# SSPR generation

Pete Anslow, Ciena

IEEE P802.3bs Task Force, Logic Ad Hoc, October 2016

Figure 49–9—PRBS31 pattern generator

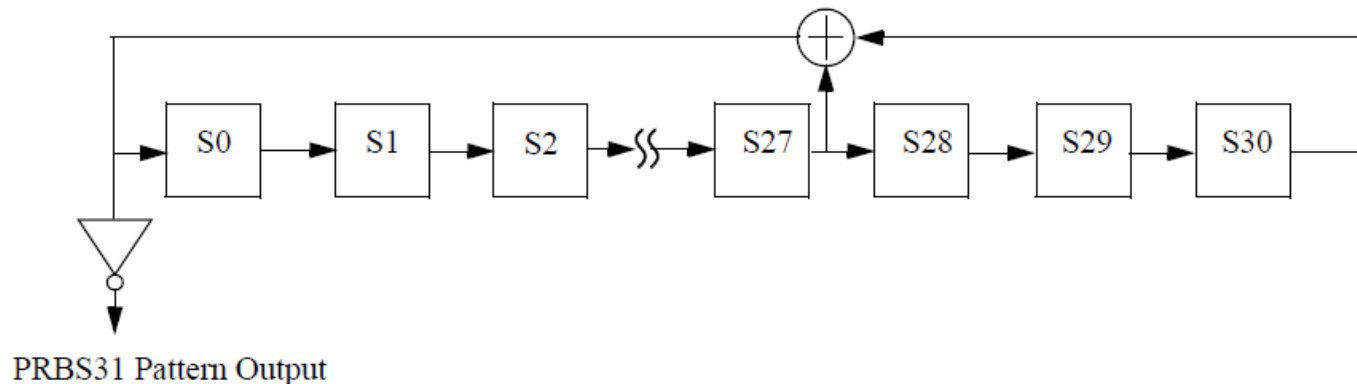
However, the PRBS31 generator that was used to generate the sequence in [anslow\\_01\\_0416\\_logic](#) was an different to that used by the PRBS31 generator referenced from 120.5.11.2.5, which is shown below:

Unlike the generator used for [anslow\\_01\\_0416\\_logic](#) the above generator does not output the seed as the first 31 bits of the sequence and it has an inverter at the output.

The consequence of using the generator from Figure 49-9 with the definition of 120.5.11.2.5 is that the resulting pattern has very different characteristics from the ones intended.

However, this can be fairly easily remedied by changing the definition in 120.5.11.2.5 so that the hex values in Table 120-2 are the seed for the generator rather than the first 31 bits of each section.

Each section of PRBS31 is generated as if produced by the shift register implementation shown in Figure 49-9 and the seed is a 31-bit hexadecimal value used to preset S30 through S0 (S30 is set to the MSB and S0 is set to the LSB) prior to the generation of the PRBS31 sequence for the indicated length of bits.
